Report: PRELIMINARY TAB REPORT

Function: Test, Adjust, & Balance

10-14-24 ULTA 1697 SELMA, NC

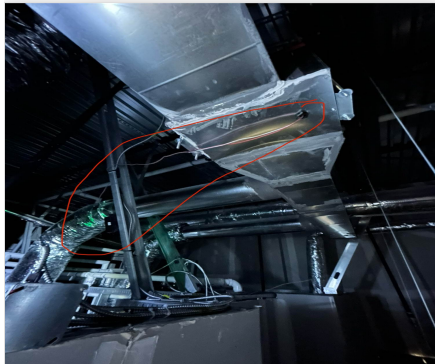
Issue Name : EF-2 Dampers not installed
Description : EF-2 dampers are not installed. However the airflows are proportional so they likely will not be required.
Created By : National TAB **Assigned To :** National TAB - Dan Hertenstein
Status : Open
Priority : Low **Asset Tag :** EF2
Originated Date : 10/17/2024 - Will Turnbough - National TAB

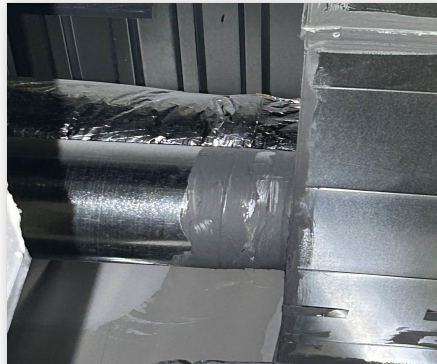
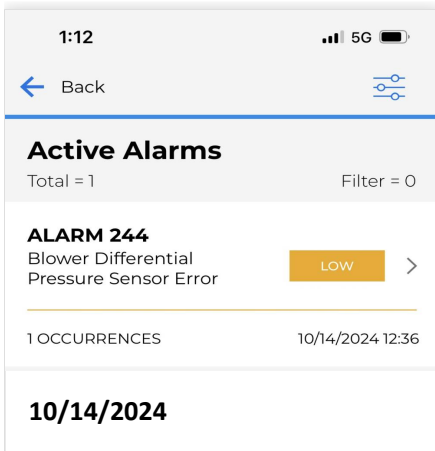
Issue Name : EF-2 Restroom fan unable to access
Description : EF-2 speed controller is located above hard ceiling and is inaccessible. Unable to reach from other side with ladder due to piping obstructing access. The unit is running at 117% of design.
Created By : National TAB **Assigned To :** National TAB - Dan Hertenstein
Status : Open
Priority : High **Asset Tag :**
Originated Date : 10/14/2024 - Jearod Ferrette - National TAB

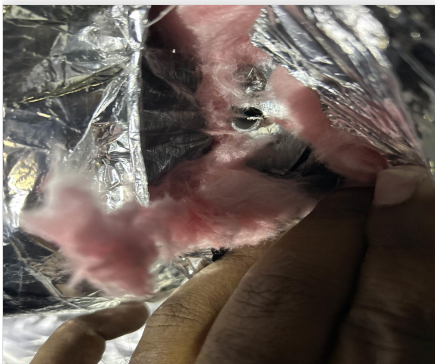
Issue Name : RTU-2 diffuser 24 damper is closed
Description : Damper for diffuser 24 is closed and not accessible. There is a shelf that is directly underneath the damper. Damper is also installed on the top of the duct. It needs to be opened and a face accessible opposed blade damper is recommended in case further balancing is required.
